ADDENDUM #1**1.1 PROJECT INFORMATION**

- A. Project Number: 2026-11230
- B. Project Title: BEB On-Route Charging Infrastructure
- C. Project Location: STA's Valley Transit Center at 10501 E 4th Ave, Spokane Valley, WA & Liberty Lake Park & Ride at 22501 E Mission Ave, Liberty Lake, WA
- D. Agency: Spokane Transit Authority

STA Route 9 BEB Charging Addendum #1 Narrative

E-101

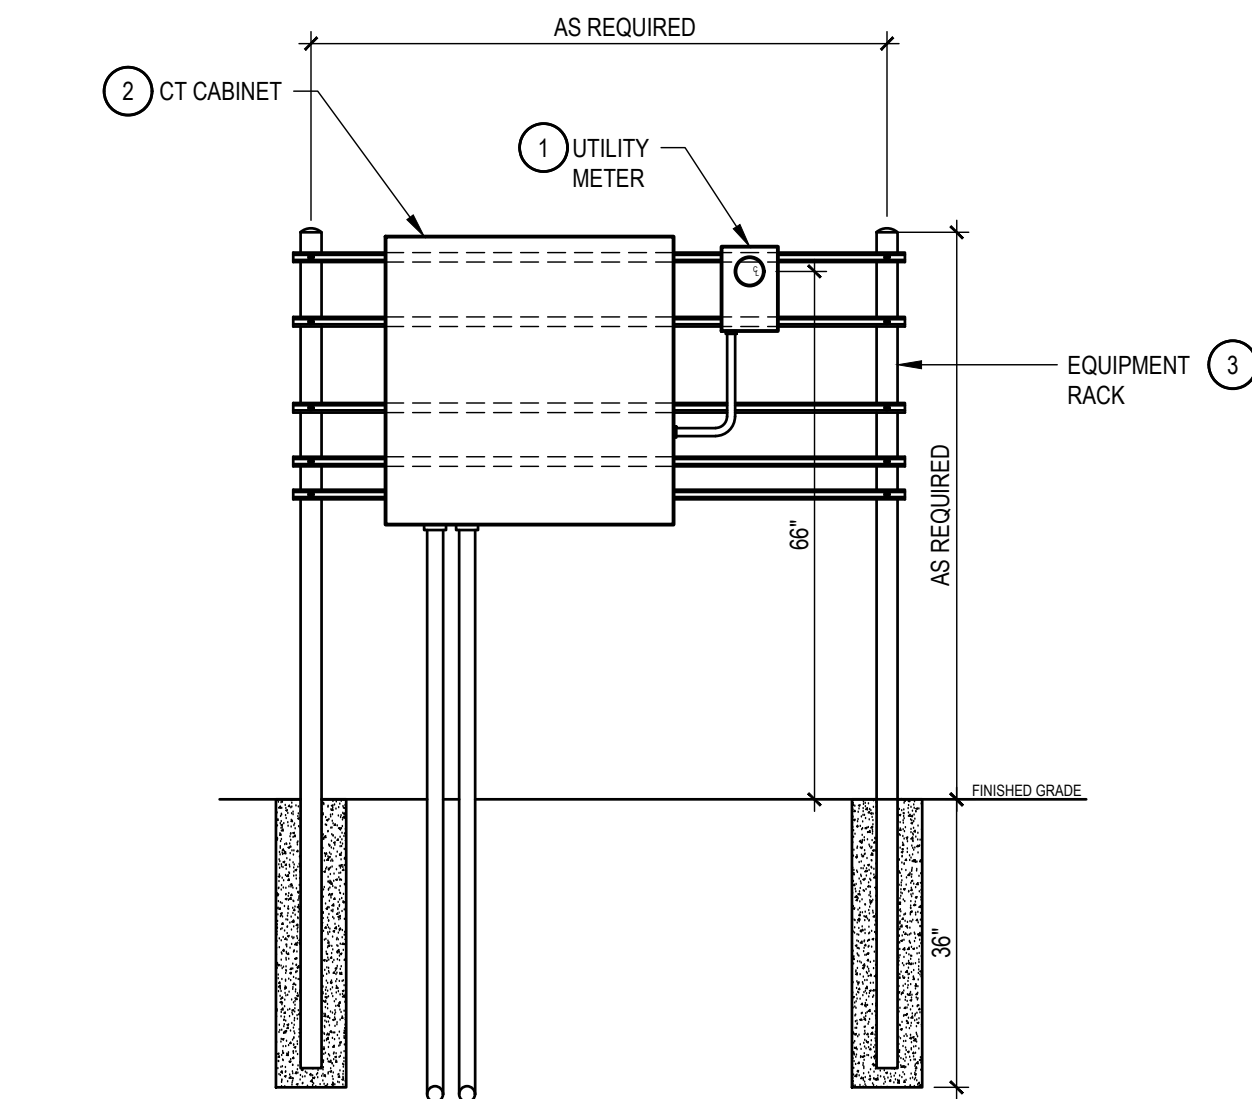
E. SHEET E-101 – PARTIAL ELECTRICAL PLAN - NORTH

1. Updated: Sheet notes and detailing of new utility service based on Modern Electric plan review comments.

- CONTRACTOR TO PROVIDE METER SOCKET WITH MANUAL LEVEL BYPASS PER UTILITY SPECIFICATIONS.
- CT ENCLOSURE SHALL BE A MINIMUM OF 36"x36"x11". PROVIDE AND INSTALL PER UTILITY SPECIFICATIONS.

- PROVIDE CONDUIT AND CONDUCTORS REQUIRED FOR CT/METERING PER UTILITY SPECIFICATIONS.
- CONTRACTOR TO PROVIDE AND INSTALL NEW E-11 CONCRETE VAULT AND LID PER UTILITY SPECIFICATIONS. TRANSFORMER TO BE PROVIDED AND INSTALLED BY UTILITY.

- UTILITY TO RE-ROUTE EXISTING PRIMARY SERVICE INTO NEW UTILITY VAULT.
- CONTRACTOR TO PROVIDE AND INSTALL E-11 CONCRETE JUNCTION VAULT AT POLE BASE PER UTILITY SPECIFICATIONS.

SHEET NO:
E-102

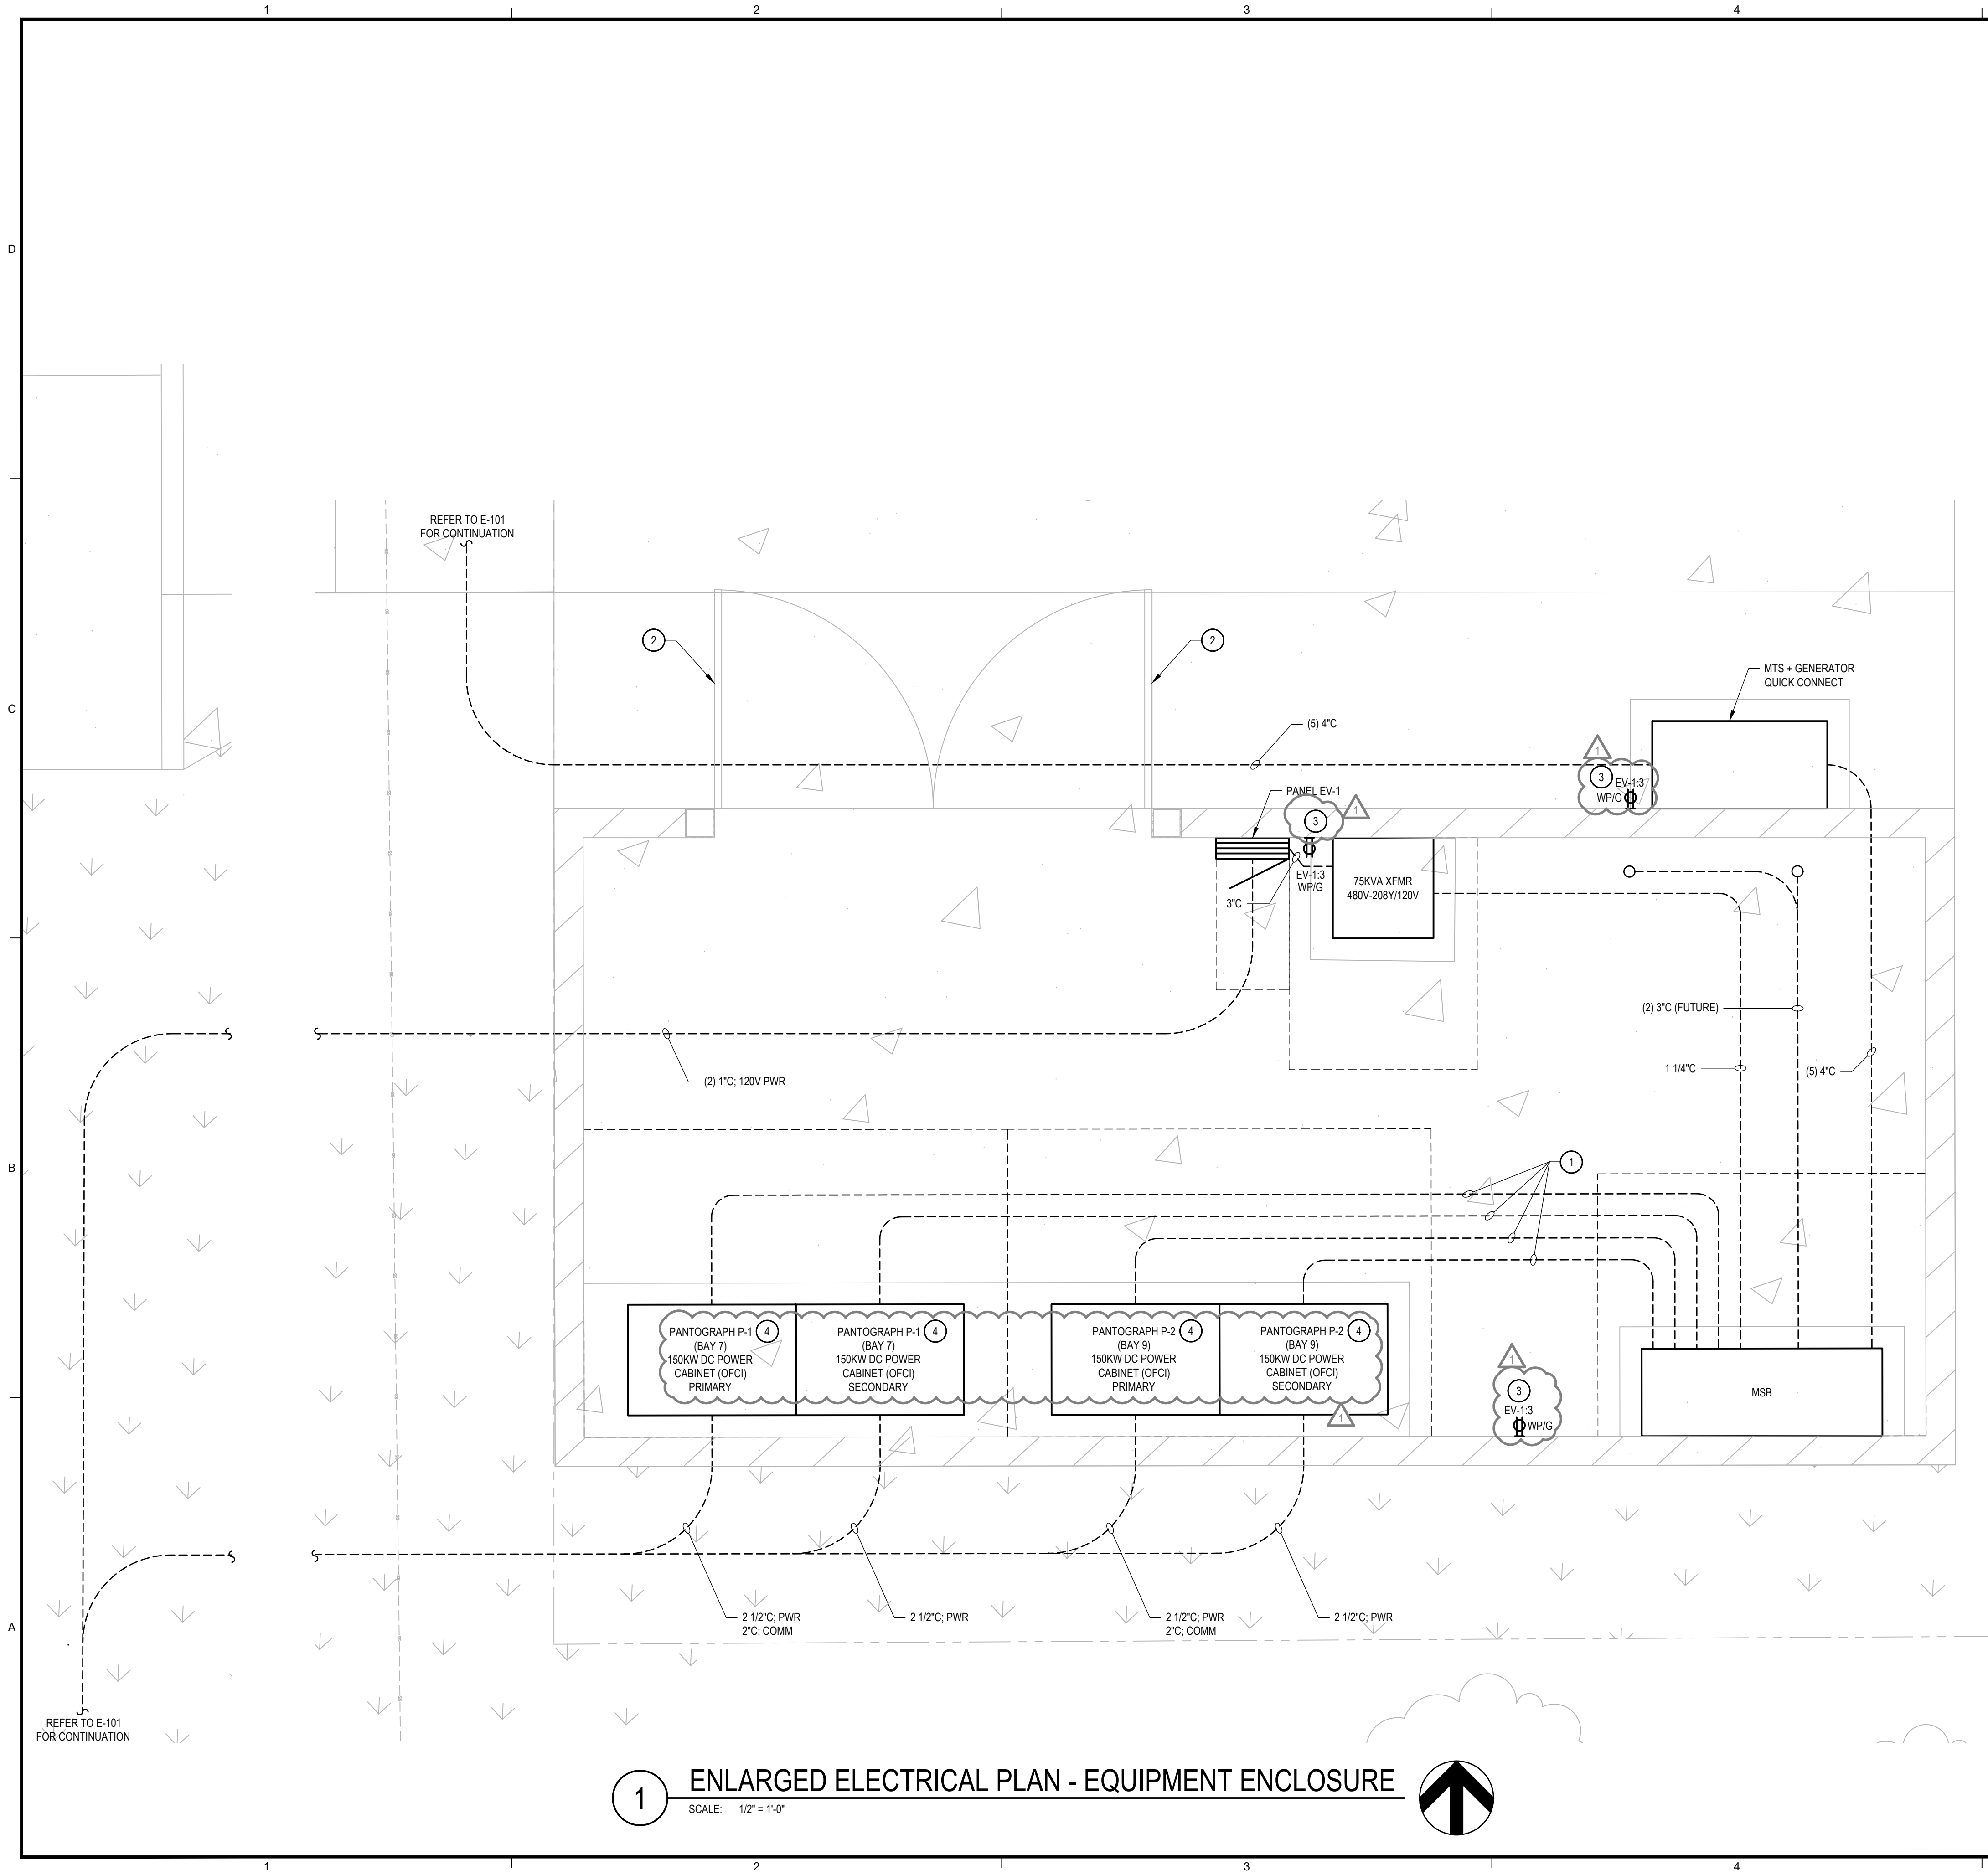
F. SHEET E-102 – PARTIAL ELECTRICAL PLAN SOUTH

1. Revised: E-stop tag and keyed note 2 to clarify labeling requirements.
